## **Maine Department of Inland Fisheries & Wildlife Comments**

- MDIFW Review Comments dated October 9, 2013
- Response by First Wind and Stantec dated October 18, 2013
- Additional Comment by MDIFW dated December 9, 2013

<b>Comments - Environmental Project Review</b>	
<b>Maine Department of Inland Fisheries and Wildlife</b>	
<b>Bureau of Resource Management Comments - Regions D &amp; E</b>	
Applicant's Name: Blue Sky West & Blue Sky West II (subsidiaries of First Wind Energy)	
Project #: # L-25973-24-A-N / L-25973-TG-B-N	Regulatory Agency: MDEP
Project Type: utility-scale wind energy facility	Project Manager: Daniel Courtemanch
"Final Agency Comments" Sent: October 9, 2013	MDIFW Contact: Charles Todd
<b>Project Location</b>	
Towns: Bingham, Mayfield Township, Moscow	County: Somerset
Towns: Abbott, Kingsbury Plantation, Parkman	County: Piscataquis
Biologists (review coordinators): Bethany Atkins, John Perry, Bob Stratton, Charlie Todd	
Biologists (Fisheries Division): Dave Boucher, Tim Obrey, Robert VanRiper	
Biologists (Wildlife Division): Bob Cordes, Danielle D'Auria, John Depue, Shawn Haskell, Tom Hodgman, Doug Kane, Amy Meehan, Beth Swartz

**BIGELOW BROOK**

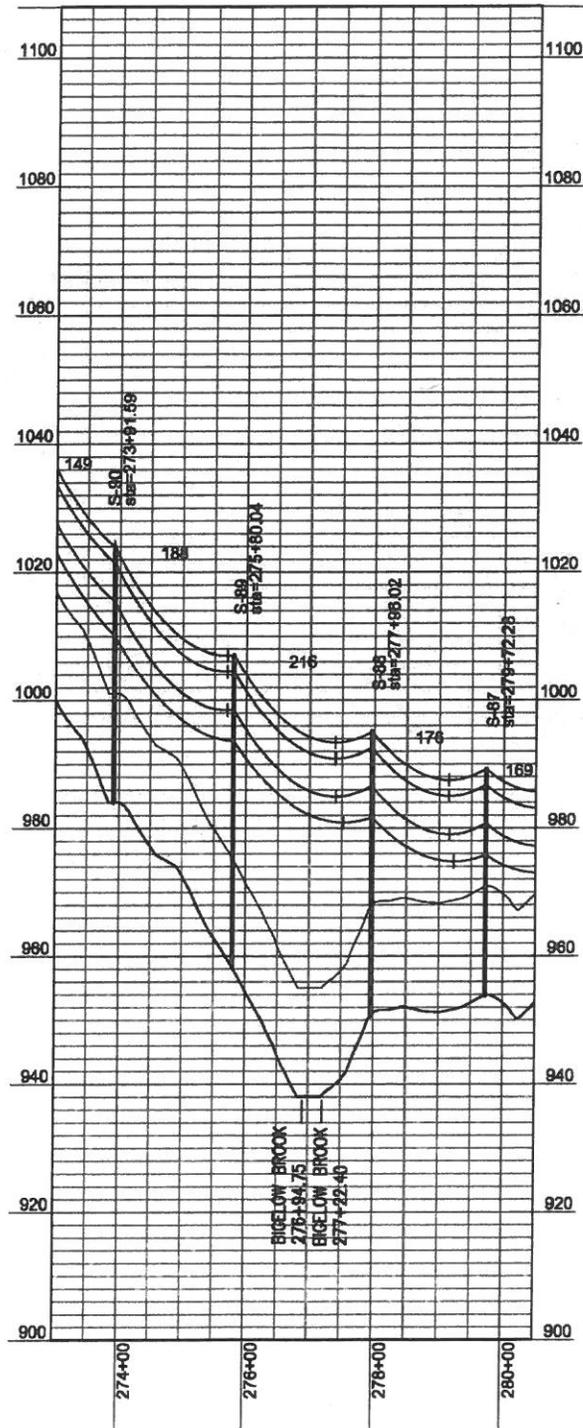
Bigelow Brook — The collector line will cross Bigelow Brook approximately 185 feet northwest of the Route 16 crossing. A steep bank on the west side of the stream should help increase conductor height over the stream and reduce the number of trees that will need to be topped.

An approximately 42-foot-tall canopy will be retained within 25-feet on either side of the stream.

**BEAR BROOK**

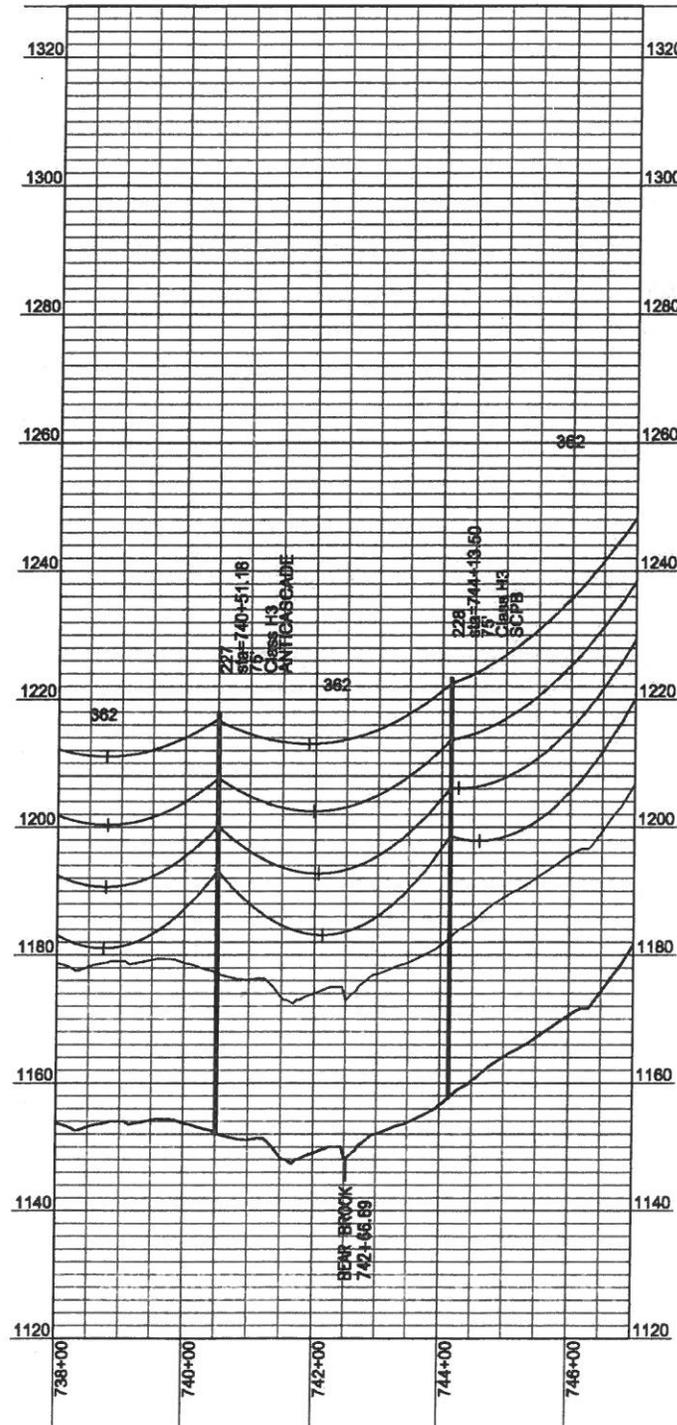
**Bear Brook** — Bear Brook is situated in a small valley and bordered by upland forest. The surrounding forest is several feet higher than the stream and should help increase conductor height over the stream and reduce the number of trees that will need to be topped. Further, the narrow width of Bear Brook in this area will allow for the development of a dense streamside shrub community. These shrubs will provide the stream channel itself with canopy cover, limiting or mitigating any potential warming concerns.

An approximately 34-foot-tall canopy will be retained within 25-feet on either side of the stream.

**BOTTLE BROOK**

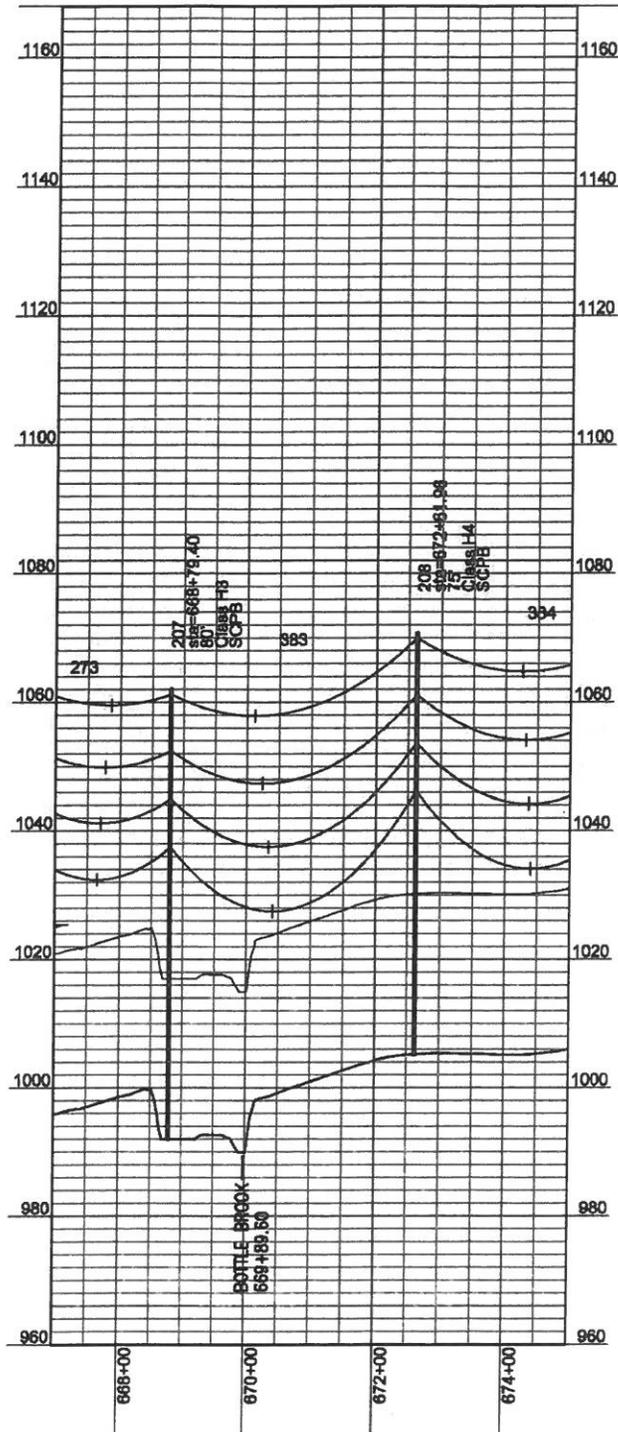
**Bottle Brook** — Bottle Brook is situated in a small valley. A steep slope leads down to the stream from the west. This slope should help increase conductor height over the stream and reduce the number of trees that will need to be topped. Timber harvesting operations occurred within the last 3-4 years on the east side of the stream. Disturbance and tree removal extends to within approximately 25-35 feet of the stream bank. A limited number of trees remain on the east bank that will need to be topped. Vegetation maintenance at this crossing will allow for the reestablishment of dense shrubs and saplings along the banks of this narrow brook, particularly along the previously impacted eastern bank. This shrub and sapling development will provide shading to the already exposed stream channel.

An approximately 34-foot-tall canopy will be retained within 25-feet on either side of the stream.

**KINGSBURY STREAM**

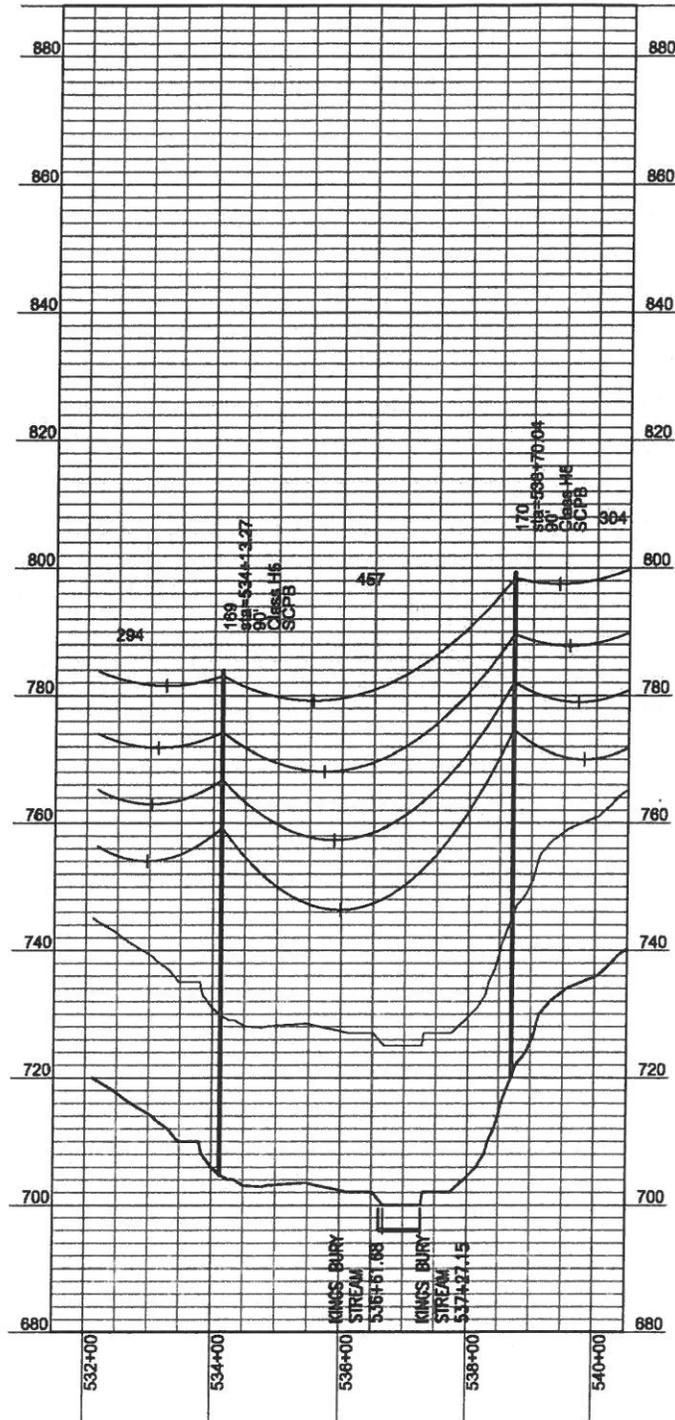
Kingsbury Stream — The generator lead will cross Kingsbury Stream adjacent to an existing bridge. Current conditions in this area provide little shading of the stream. It is likely that topping trees within 100 feet of the Kingsbury Stream will not result in adverse impacts to the stream. While some trees currently providing some shade to the channel will be removed, the width of the stream already creates a high degree of sun exposure.
